BALCONES ESTATES SOUTH

P.O.A.D.P.

Re: Balcones Estates South

POADP # 567

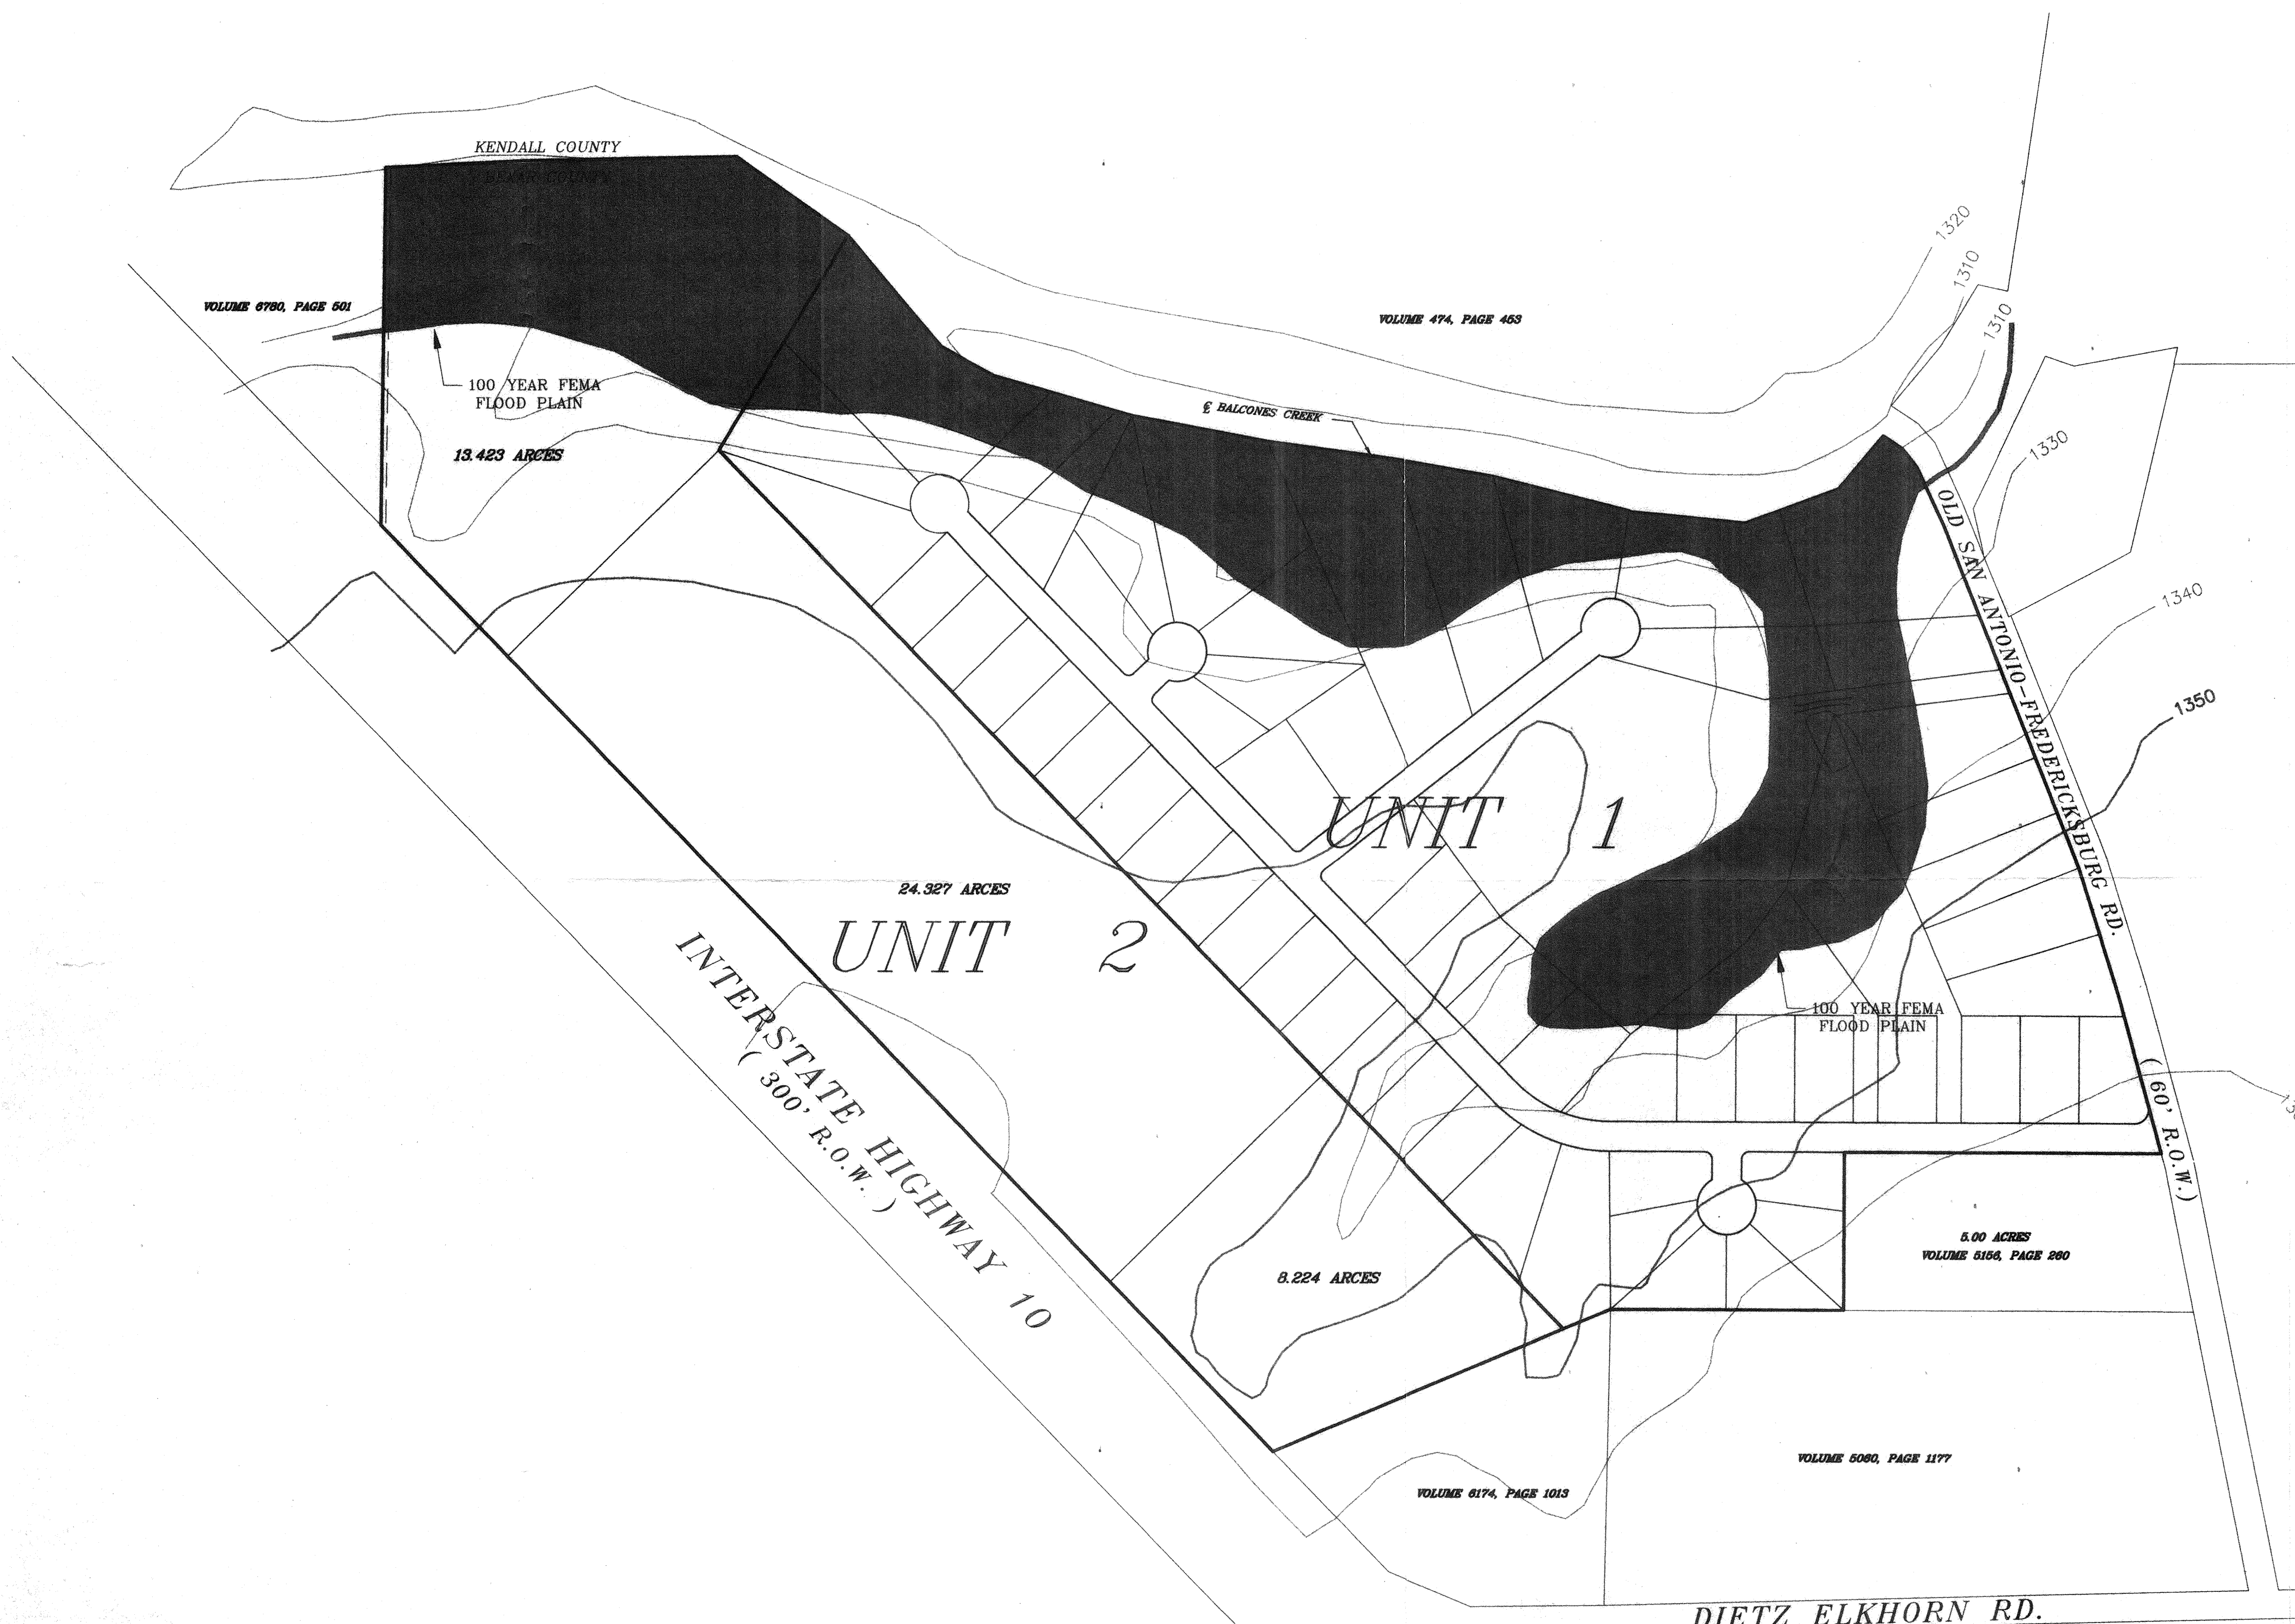
- Access and R.O.W. issues along State facilities will need to be resolved with the Texas Department of Transportation (TXDOT). For additional information about these requirements you can contact TXDOT at 615-5814.
- Based on the topography, a Flood Plain Study and drainage review will probably be required during the platting process.
- This plan will need to conform to requirements associated with development over the Edwards Aquifer. For additional information about these requirements you can contact SAWS at 704-7305.
- This development will need to comply with tree preservation ordinance #85262. For additional information about these requirements you can contact Building Inspections at 207-7102.

Comments: Flood plain requirements and drainage  
easements will be require and will be address  
during the platting process.

For residential development directly adjacent to State ROW, the developer shall be responsible for adequate set-back and/or sound abatement.

Maximum access points to State Highways from this property and locations of access points will be as directed by "Regulations For Access Driveways to State Highways".

A complete copy of the approved WPAP will be required at the time of platting. State right of way will not be utilized for the purposes of treating storm water runoff from adjacent property.

Permit applications along with plans for street, driveway, utility, sidewalk and drainage construction must be submitted to the Texas Department of Transportation for review and approval before working on highway ROW. TxDOT requires that a recorded plat accompany all driveway permit applications. The Owner/Developer is responsible for preventing any adverse impact to the existing drainage system within highway ROW.
